October 2023
FL981AB
NHTSA #23V-621

Subject: TBB Loose AC Ground Stud

Models Affected: Specific model year 2024 Thomas Built Buses (TBB) Saf-T-Liner C2 buses manufactured May 1, 2023, through August 31, 2023.

Fig. 1, Location of the A/C Ground Connection

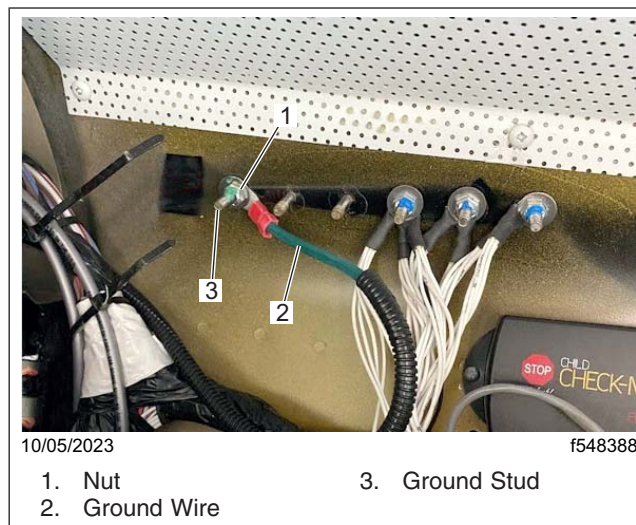
On the affected vehicles, the electrical cables for the air conditioning (AC) may not be installed properly, which can allow the electrical connection to overheat. An overheated electrical connection increases the risk of a fire.

4. Locate the glove box on the left-hand side of the driver's overhead compartment. Locate and remove the two square-head screws that hold the inner liner of the glove box in place.
5. Inspect the nut on the grounding stud to make sure it is securely fastened. See [Fig. 1](#).

6. If found loose, tighten the fastener 95 lbf-in (1073 N-cm).
7. If the ground stud breaks, connect the ground to a different stud.
8. If the nut is not fastened securely, inspect the wiring for any damage. If the ground wire is damaged, contact TBB for further guidance.

Fig. 2, Ground Stud Referencing Rear A/C Evaporator

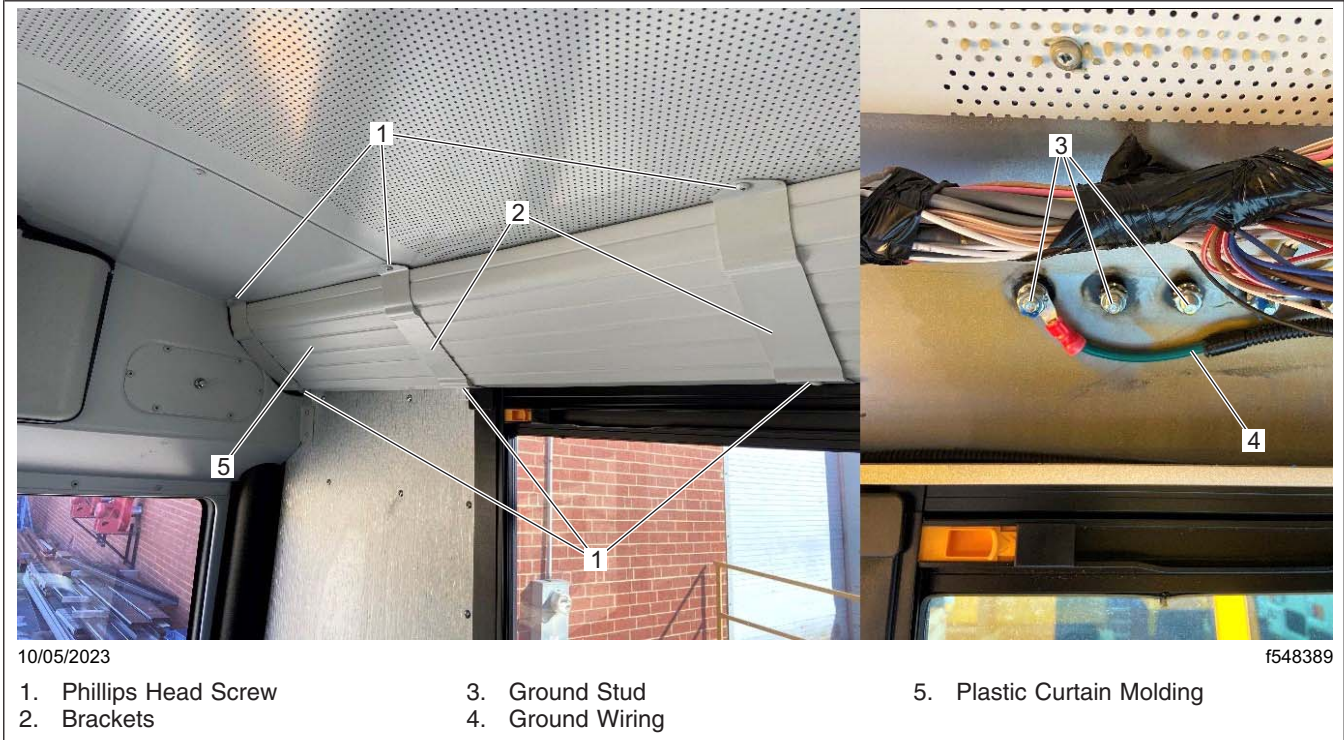
9. Remove the Phillips head screws from the brackets that hold the plastic curtain molding. This allows to pull the curtain molding away enough to see the metal header with the ground studs. See [Fig. 2](#).

10. Inspect the nut on the grounding stud for tightness.
11. If found loose, tighten the fastener 95 lbf-in (1073 N-cm).
12. If the ground stud breaks, connect the ground to a different stud.
13. If the nut is not fastened securely, inspect the wiring for any damage. If the ground wire is damaged, contact TBB for further guidance.

Fig. 3, BCC Module

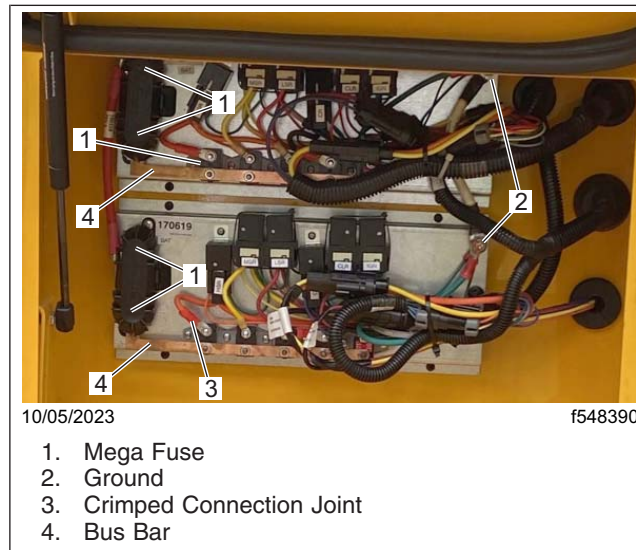
15. Check if the nuts that attach the cables to the bus climate control (BCC) modules are properly tightened. Tighten the B (+) connectors between the cables and the mega fuses 95 lbf-in (1073 N-cm). See **Fig. 3**.

16. Inspect all the wires and connections on the control module that are connected to the bus bar. The joints should not be loose. If found loose, tighten the nuts that connect the wires to the bus bar 24 to 32 lbf-in (271 to 362 N-cm).
17. Check all the crimped connection joints so that the wires are firmly connected.
18. Connect the negative terminals to the battery.
19. Turn the MPDS to the ON position.
